UNITED STATES PATENT AND TRADEMARK OFFICE

Office Action Summary

10/589,946

DETAILED ACTION

Excerpt of Konopka Fig. 4

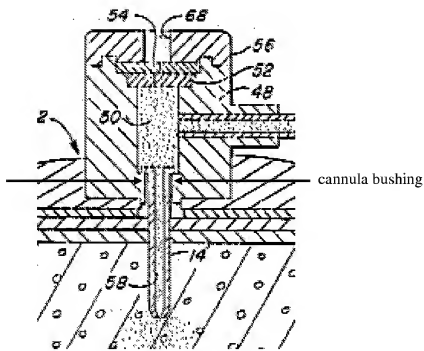
Claim 33: at least one end of the tubular element provides a substantially partial enclosure over one surface of the septum (Fig. 4, #68 – aperture 68 exposes the septum and provides substantially partial enclosure);

Claim 34: one end of the tubular element is open and leaves the surface of the septum exposed (Fig. 4, #68);

Claim 35: the tubular element is a cannula bushing (Fig. 4 – no special definition was found in the specification, the plain meaning of bushing would be a "usually removable cylindrical lining for an opening used to limit the size of the opening, resist abrasion, or serve as a guide" Merriam-Webster <http://www.merriam-webster.com/dictionary/bushing?show=0&t=1306264971>, accessed 24 May 2011; the tubular element is a bushing that guides and retains the cannula for insertion into the patient's skin);
